Stage 2 Road Safety Audit

City of Edinburgh Council

GREENBANK - MEADOWS CYCLE ROUTE

Document title: Greenbank to Meadows - Stage 2 Road Safety Audit

Problem	3.3	
Location(s):	Scheme Extents- Parking bays adjacent to cycle lanes	
Drawing(s):	330610712-STN-HGN-02-DR-CH-0107 to 0110	
Summary:	Risk of collisions between cyclists and drivers existing/entering vehicles.

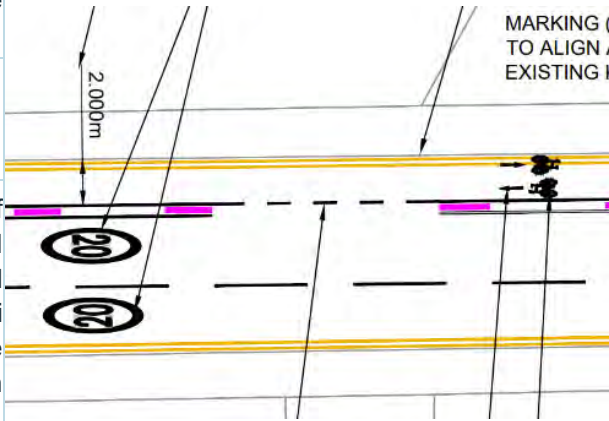
Parking bays are proposed adjacent to cycle lanes at various locations throughout the scheme extents. At these locations a 0.535m 'buffer' is proposed consisting of an 150mm road marking, 235mm kerb defender and 150mm cycle lane marking.

Whilst it is acknowledged a response has been provided to the potential risk of trips and falls when accessing and egressing the bays (RSA Stage 1 Problem Ref 3.6) it is also anticipated that the parking bay proposals may present the following risks:

- people will be required to load / unload from the cycle lane, potentially causing obstructions which may contribute to risk of pedestrian and cycle collisions; and
- cyclists may be injured by striking vehicle doors opening into the cycle lane, particularly as vehicles are likely to park within the road marking extents, close to the defender kerbs. A 0.5m buffer would therefore not be achieved.

It is recommended that sufficient buffer width is provided between parking bays and cycleways and /or an alternative parking or cycle facility arrangement is provided.

Problem:	3.5
Location(s):	Western Scheme Extents - Hermitage Drive at Braid Road
Drawing(s):	330610712-STN-HGN-02-DR-CH-0107
Summary:	Risk of cyclists becoming destabilised when transitioning between cycle and shared use facilities

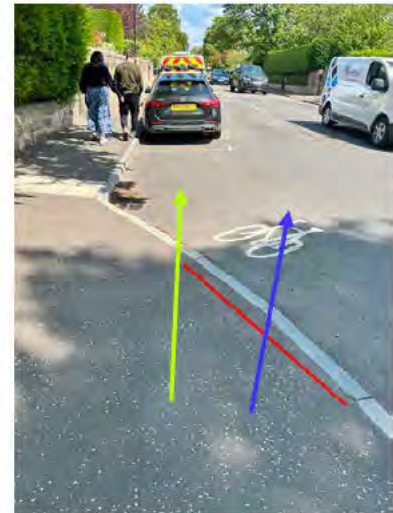
At the western scheme extents, the proposed two-way cycle lanes will transition to and from an existing shared use area at footway level (Green arrow). However, the current flush kerb extents (shown in red above) and cycle road marking do not align with the proposed cycle lanes, directing cyclists into the primary position within the carriageway (Blue arrow). There is a risk that cyclists transitioning between the two facilities may become unsteadied when making sharp manoeuvres or when crossing the drop kerb at an acute angle which may lead to falls and an increased the risk of injury.

Furthermore, as pictured above, the extents of the dropped kerb are unclear on approach to the proposed two-way cycle lanes. There is a risk that during periods of inclement weather such as snow fall or leaf litter accumulation may further obscure the dropped kerb extents. It is anticipated cyclists will proceed directly between the cycle lanes and shared area, at risk of colliding with full height kerbs. This may contribute to injury from falls.

It is recommended that the existing flush kerb and/or markings are altered to better direct cyclists between the proposed cycle facility and the shared use path.

Problem:	3.6	
Location(s):	Hermitage Drive - at junction with Corrennie Gardens	
Drawing(s):	330610712-STN-HGN-02-DR-CH-0107	
Summary:	Drivers emerging from or accessing the side road may not realise the cycle lane is bidirectional which may contribute to collisions with cyclists.

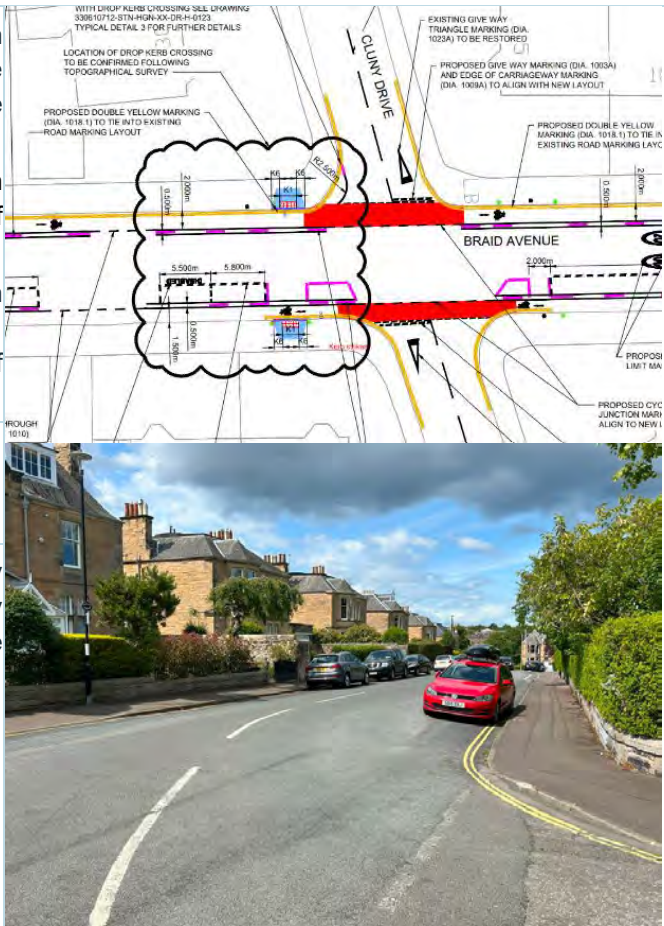
The proposals include a bidirectional cycle lane on the northern side of Hermitage Drive. Drivers crossing the cycle lane may not be aware that it facilitates two-way cycling and may therefore not look for cyclists travelling in both directions along the proposed cycle lane. This may contribute to side impact collisions between cyclists (particularly westbound cyclists) and motorists crossing the lane. This risk is heightened by the inconsistency in cycling infrastructure in the surrounding area, where facilities alternate between uni-directional and bi-directional layouts.

It is recommended that cycle markings and/or signage are provided, positioned in the view of drivers approaching the junction, to inform drivers of the potential for two-way cycle movements.

Problem:	3.10
Location(s):	Braid Avenue Extents
Drawing(s):	330610712-STN-HGN-02-DR-CH-0108 to 0110
Summary:	Proximity of formalised parking bays to accesses may restrict intervisibility between users.

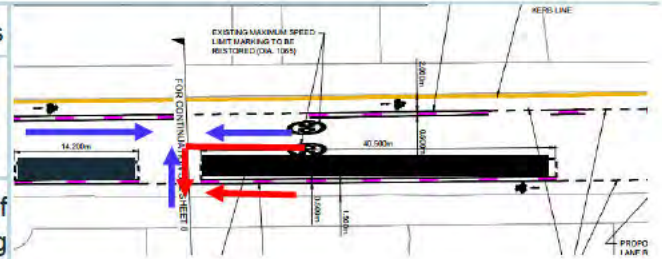
Formalised parking facilities are proposed along Braid Avenue in close proximity to existing accesses. When the parking bays are occupied, it is anticipated that:

- parked vehicles may obstruct visibility between drivers exiting the accesses to vehicles on the mainline, increasing the likelihood of side impact collisions (blue arrows above); and
- parked vehicles may obstruct visibility of cyclists travelling along the cycle way from drivers tuning into accesses (particularly where long lengths of parking bays are proposed) which may contribute to collisions between vehicles and cyclists (red arrows above).

It is recommended that parking bay extents are amended to allow sufficient intervisibility between road users.

Problem:	3.16	
Location(s):	Uncontrolled pedestrian crossing of Braid Avenue, south of Cluny Drive	
Drawing(s):	330610712-STN-HGN-02-DR-CH-0109	
Summary:	Gully within proposed pedestrian crossing may contribute to the likelihood of slips and falls

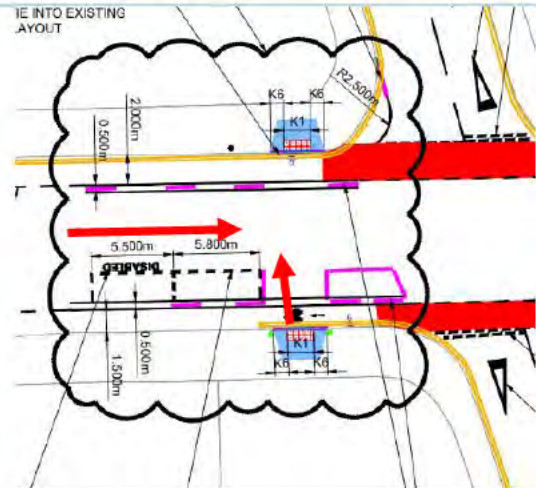
During the site visit it was observed that a gully will be located in the proposed pedestrian crossing of Braid Avenue. This increases the risk of pedestrian slips and falls which could result in injury. There is also potential for footwear, such as high heels to be caught in the open grating, which may also give rise to injury from falls

It is recommended that the gully is relocated, or the crossing be relocated out with the gully location.

Problem:	3.19	
Location(s):	Comiston Road and Whitehouse Loan	
Drawing(s):	330610712-STN-HGN-02-DR-CH-0106 & 0125	
Summary:	Obstructed signage may increase the risk of sudden or late manoeuvring.

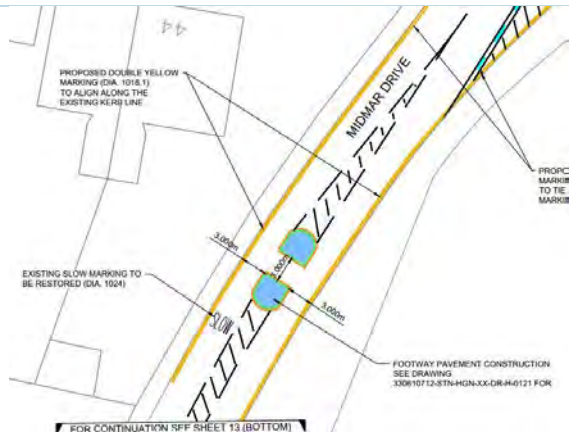
Overhanging vegetation was observed where the proposed cycle direction signs on Comiston Road and Whitehouse Loan are to be mounted, most likely obstructing them from road user view. Without advanced warning of the cycle route's continuation which enables cyclists to position themselves appropriately for upcoming turning manoeuvres, there is a risk of cyclists making late or sudden manoeuvres. This may contribute to falls or collisions with other road users.

It is recommended that vegetation is cut back to provide suitable visibility to signs.
